Report: TAB

Function: Test, Adjust, & Balance

Date: 03/17/2025

**03-10-25 WHATABURGER #1582 GASTONIA,
NC**

- RTU1 / SGRD9 Duct Size

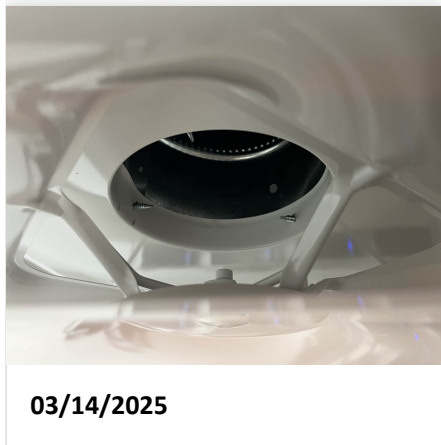
Issue Name : RTU1 / SGRD9 Duct Size
Description : SGRD9 IS LOW OF DESIGN CFM DUE TO THE WRONG SIZED DUCTWORK BEING INSTALLED. A 6" DUCT WAS INSTALLED WHEN PLANS CALL FOR A 8". SPENT OVER AN HOUR TRYING TO PUSH AIR TO SGRD9 BUT WAS UNABLE TO INCREASE SUPPLY AIR TO DESIGN CFM.
Created By : National TAB **Assigned To :** National TAB - Dan Hertenstein
Status : Open
Priority : Medium **Asset Tag :**
Originated Date : 03/14/2025 - Dale Wheeler - National TAB

Screenshot of the GRD marked up with supply and return traverse locations for RTU-2 (Add picture here)

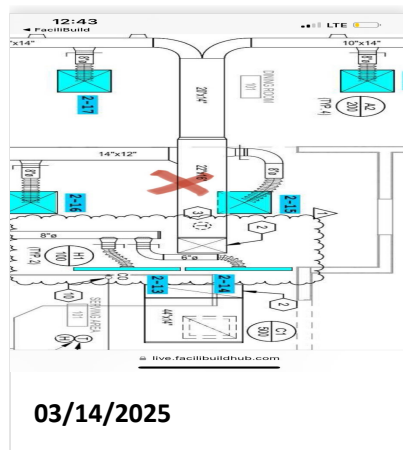
RETURN DUCT COULD NOT BE TRAVERSED DUE TO MAIN DROP / TRUCK LINE NOT HAVING A RUN OF 4FT. OR MORE OF STRAIGHT DUCTWORK. UNABLE TO TAKE AN ACCURATE TRAVERSE DUE TO THIS ISSUE SUPPLY DUCTWORK WAS TRAVEERSED & HOLES PLUGED AND INSULATION RETAPED. GRD MARKED WITH RED X SHOWING WHERE TRAVERSE WAS TAKEN.

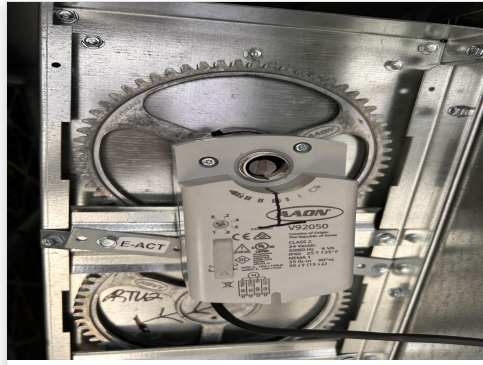
- [1] BALANCE SCHEDULE CALLS FOR UNIT TOTAL TO BE 2240. SUPPLY GRILLS ADD UP TO 2140 ON GRD. SUPPLY GRILLS SGRD1,4,6,10,14,17,18 DESIGNS WERE ENCREASED TO REACH 2240 CFM.
- [2] SRD13 WAS REMOVED AND SGRD14 DESIGN WAS INCREASED TO 200CFM PER G.C.
- [3] RETURN DUCT COULD NOT BE TRAVERSED DUE TO MAIN DROP / TRUCK LINE NOT HAVING A RUN OF 4FT. OR MORE OF STRAIGHT DUCTWORK. UNABLE TO TAKE AN ACCURATE TRAVERSE DUE TO THIS ISSUE.
